Revised Analyses of Decommissioning for the Reference Pressurized Water Reactor Power Station

Effects of Current Regulatory and Other Considerations on the
Financial Assurance Requirements of the Decommissioning Rule
and on Estimates of Occupational Radiation Exposure

Final Report

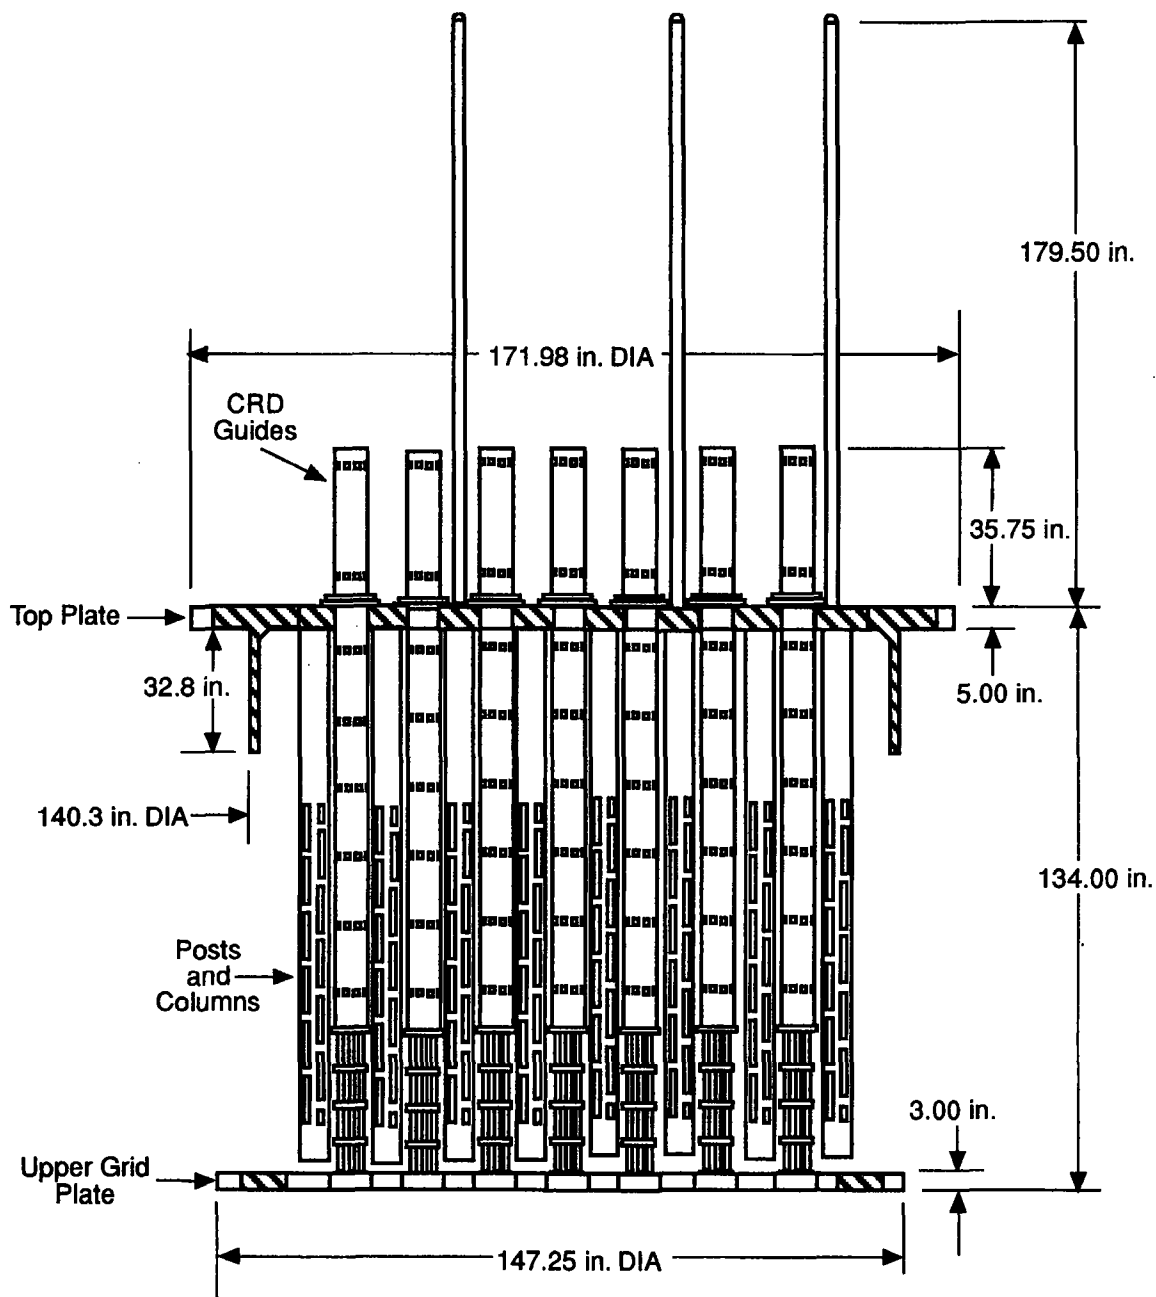
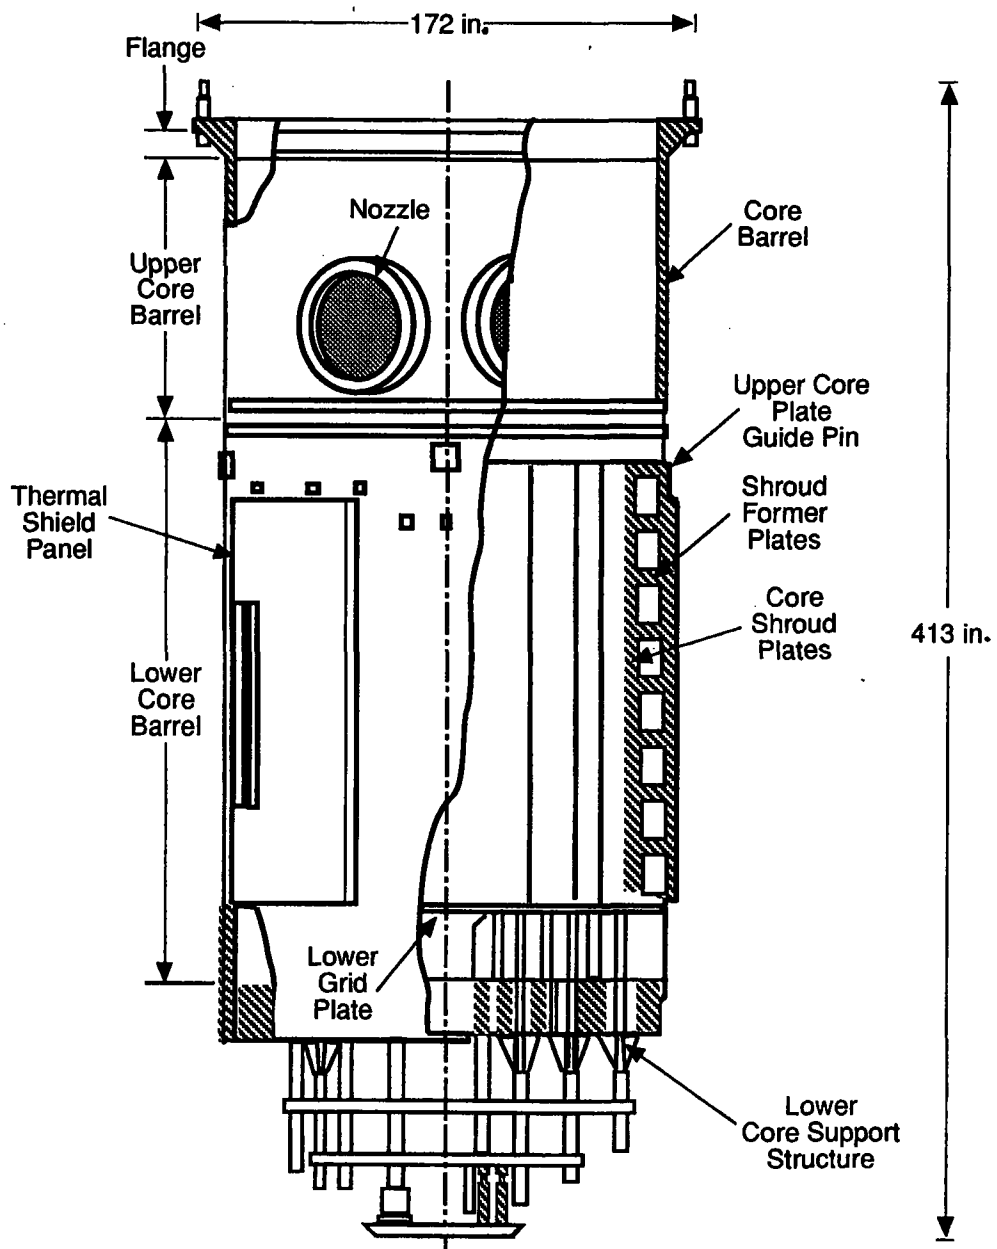
006-7 Comment: Section E describes the components of the reactor and internals. Figures E.1 and E.2 show many of these, but not all components are labeled and the names of those which are labeled do not always have the same names used in the text.
